A20 Coldharbour Roundabout

Segregated Left Turn Lane
Option Study
January 2015

Road Safety Audit Stage 1

A20 Coldharbour Roundabout, Maidstone, Kent

Figure B.1: Based on MM Drawing Number 344395HH01-SKE-A-001

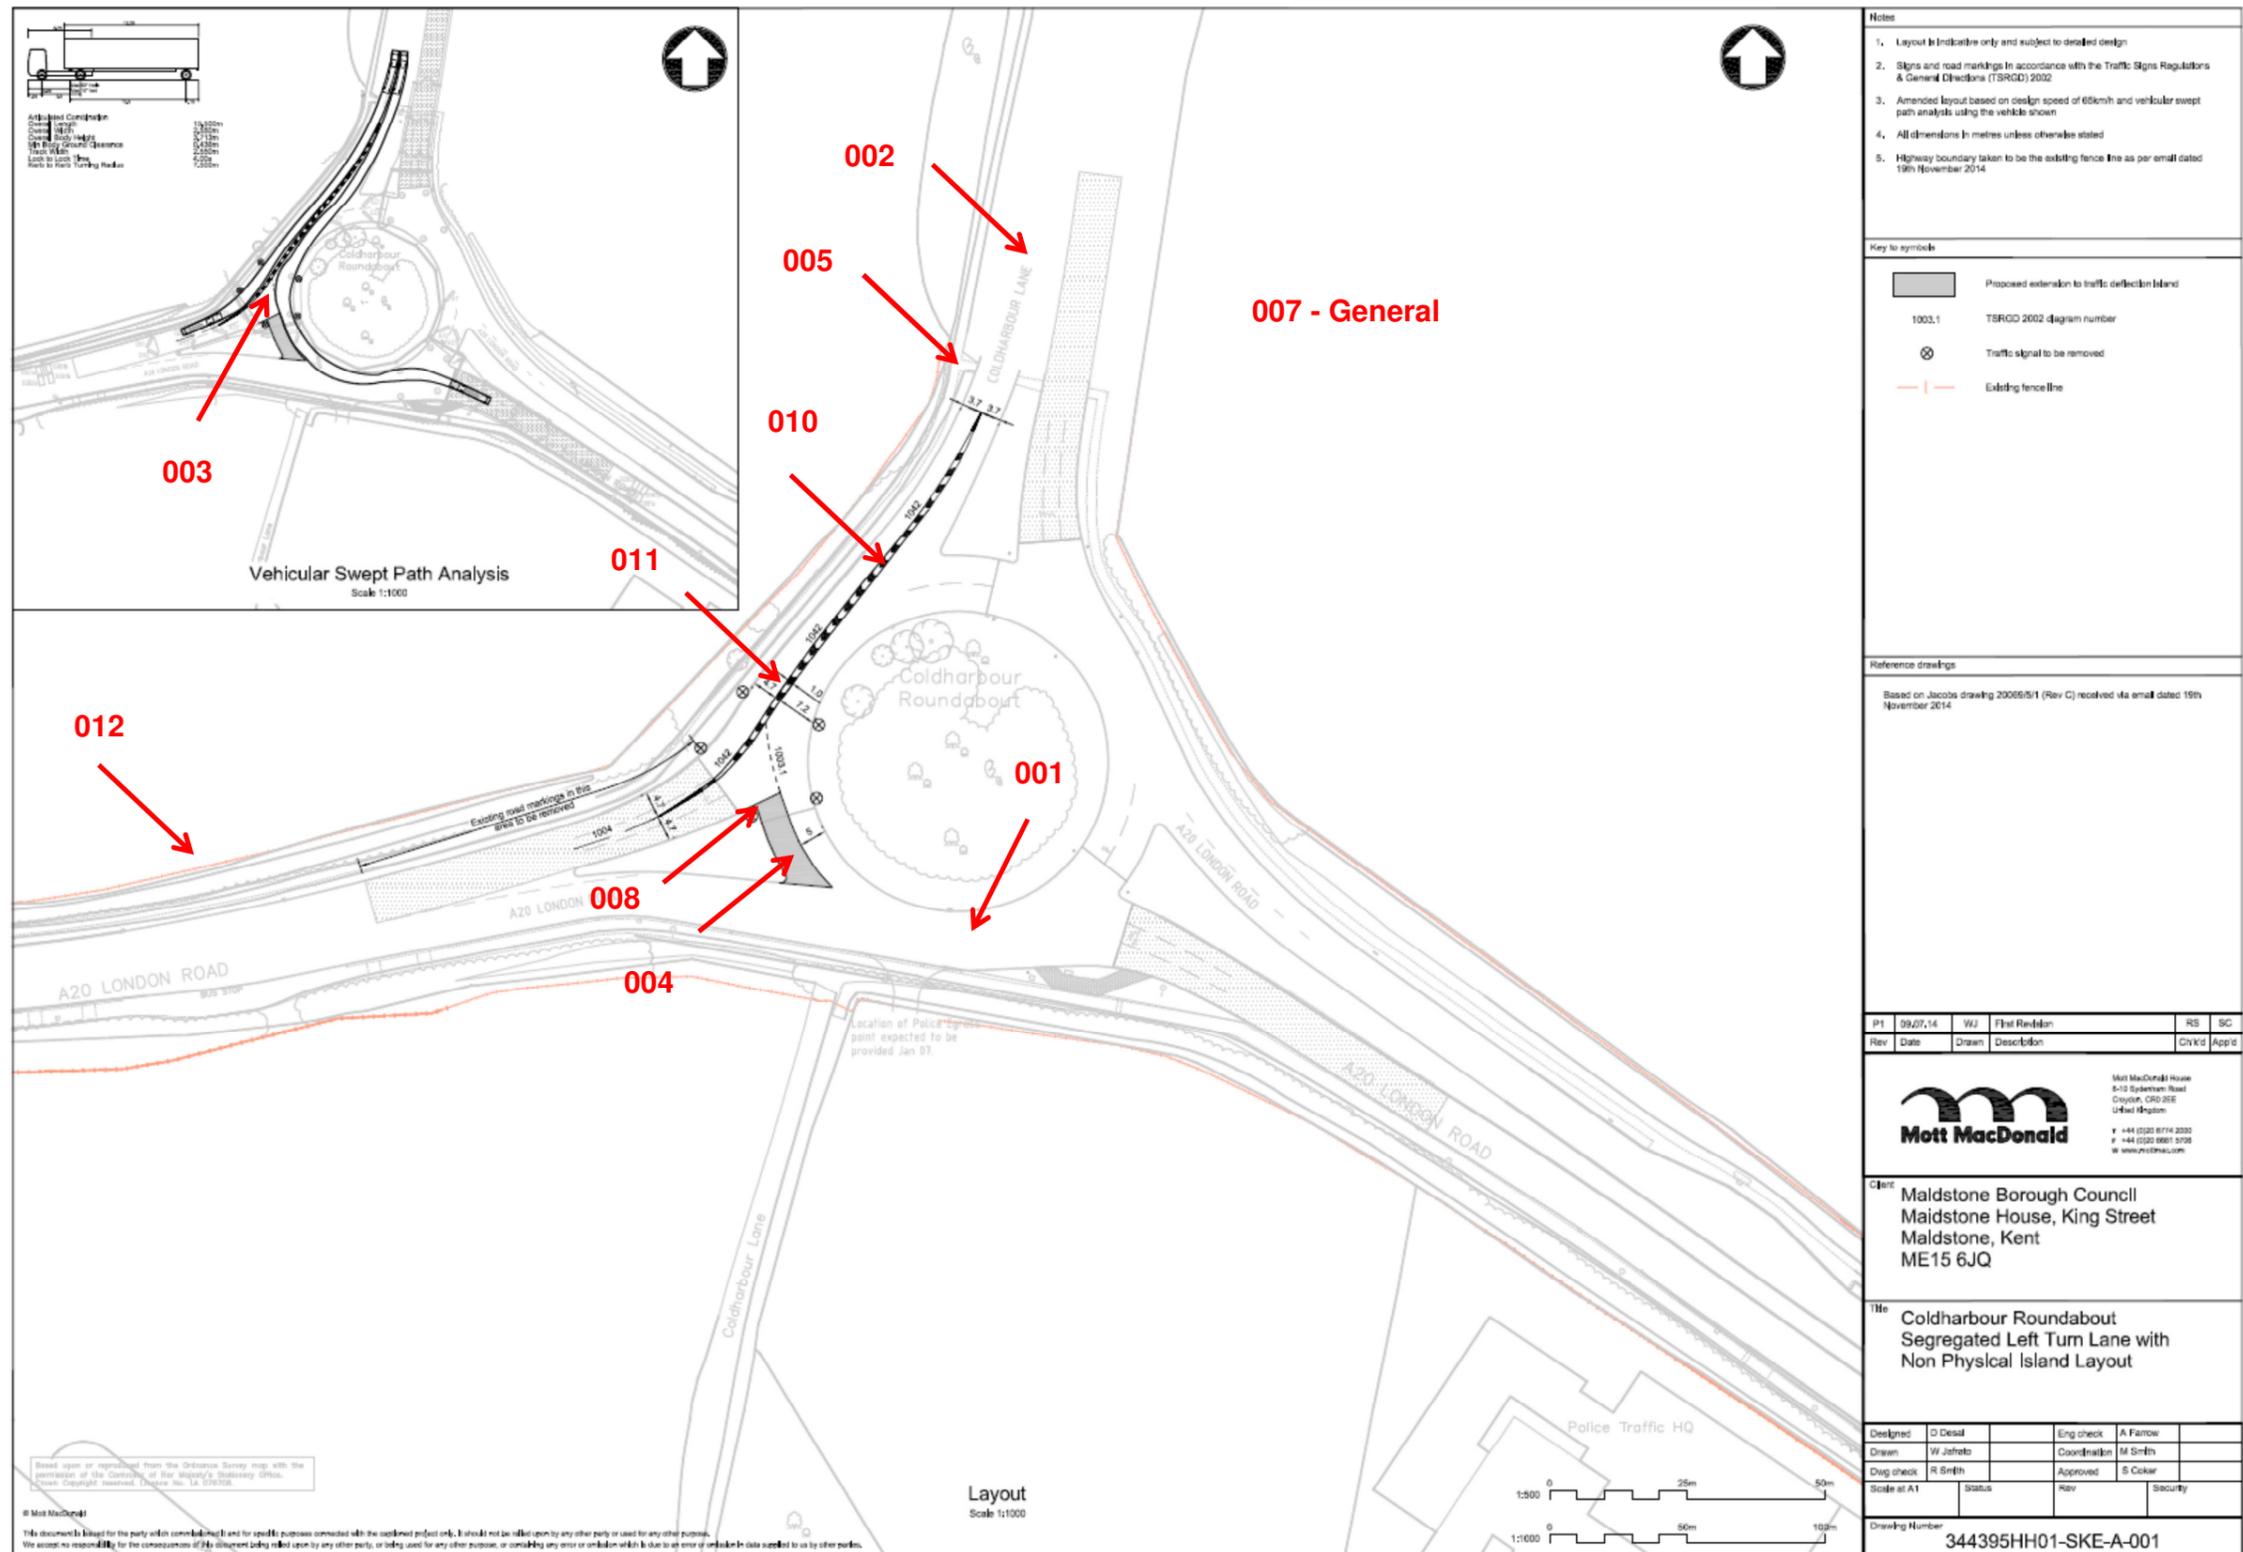
There is currently no or little lane delineation on the roundabout. This in turn results in poor lane discipline on the roundabout. Given the proposal to narrow the circulatory carriageway on its eastern side by extending the traffic island, this may result in continued conflicts, leading to side swipe accidents.

The introduction of a SLTL under both configurations will require vehicles to weave, immediately north of the exit taper. There appears to be some 200m of weaving length north of the roundabout and this link is subject to national speed limit. The audit team is concerned that vehicles may seek to change lanes immediately past the exit taper (northbound), potentially resulting in side-swipe / lane changing accidents at this location.

Drawing Numbers 344395HH01-SKE-A-001 and 002 show the vehicular swept path for both design options.

Both options show the proposed extension of the traffic deflection island on this approach.

Drawing No. 344395HH01-SKE-A-001 shows the retention of traffic signal control on the northern section of the roundabout.

Output from the road safety audit					Response from the designers
Item	Location	Summary	Description	Recommendation	
001	A20 westbound approach to the junction.	Circulatory carriageway width on roundabout.	<p>The audit team understands from the road safety audit brief that the A20 westbound approach to the roundabout is to be narrowed from three lanes to two lanes, with Lane 1 for the left/ahead movement onto the A20 and Lane 2, the right turn onto the M20 link.</p> <p>There is currently no or little lane delineation on the roundabout. This in turn results in poor lane discipline on the roundabout. Given the proposal to narrow the circulatory carriageway on its eastern side by extending the traffic island, this may result in continued conflicts, leading to side swipe accidents.</p>	It is recommended that appropriate lane markings (and hatching) are provided on the circulatory carriageway for both the east to north (right turn) movement and the east to west (ahead movement).	<p>The designers agree with the comments of the auditors.</p> <p>The drawings will be amended to reflect the suggested changes.</p>

002	A20 eastbound approach to the roundabout.	Introduction of weaving movements north of the roundabout.	<p>Drawing Numbers 344395HH01-SKE-A-001 and 002 show the proposals for the Non-Physical Island Layout and Physical Island Layout respectively. The Non-Physical Island has give-way control on the roundabout, whilst the Physical Island Option retains traffic signal control.</p> <p>The introduction of a SLTL under both configurations will require vehicles to weave, immediately north of the exit taper. There appears to be some 200m of weaving length north of the roundabout and this link is subject to national speed limit. The audit team is concerned that vehicles may seek to change lanes immediately past the exit taper (northbound), potentially resulting in side-swipe / lane changing accidents at this location.</p>	It is recommended that measures to mitigate traffic weaving, north of the SLTL are investigated.	The designers note the comments of the auditors, but they do not consider weaving to be an issue. However, this will be reviewed during the detailed design stage.

003	A20 westbound approach to the roundabout.	Tracked speed of design vehicle.	<p>Drawing Numbers 344395HH01-SKE-A-001 and 002 show the vehicular swept path for both design options.</p> <p>The tracked speed of the swept path is not stated and the audit team is concerned that for the non-physical island, the design vehicle may encroach into the SLTL if tracked speeds are not appropriate.</p> <p>This may result in side swipe accidents.</p>	It is recommended that the tracked speed for the design vehicle is checked such that it is appropriate for the roundabout geometry.	The designers note the comments of the auditors. The design vehicle, tracked at 20 mph, has been found to successfully negotiate all the affected manoeuvres on the roundabout (i.e. eastbound to northbound, eastbound to eastbound and westbound to northbound). The design vehicle was also able to successfully negotiate two of these manoeuvres (i.e. eastbound to northbound and eastbound to eastbound), when tracked at the speed limit of 40 mph.

Output from the road safety audit						Response from the designers
Item	Location	Summary	Description	Recommendation		
004	A20 eastern arm of roundabout.	Extension of traffic deflection island.	Both options show the proposed extension of the traffic deflection island on this approach. The audit team is of the opinion that this kerb extension may result in vehicles occasionally striking the kerb, as they turn from west to north.	It is recommended that the extent of the kerb extension is reduced and that an area of hatched road markings is provided in front of it.	The designers agree with the comments of the auditors. The drawings will be amended to reflect the suggested changes.	
005	A20 northbound, immediately north of roundabout.	Pedestrian crossing point.	There is an informal pedestrian crossing point, immediately north of the roundabout, on the link road up to M20 J5. During the site visit, the audit team observed the occasional crossing of the carriageway, by pedestrians, at this location. The introduction of the SLTL is likely to encourage higher vehicle speeds, with motorists unlikely to anticipate pedestrians crossing at this location. This may increase the risk of collisions with pedestrians at the crossing point.	It is recommended that measures are investigated to deter / discourage / prevent pedestrians crossing at this location. It may be necessary to provide an alternative crossing away from the SLTL, with appropriate signing / deterrents for pedestrians.	The designers note the comments of the auditors and measures will be considered during the detailed design stage.
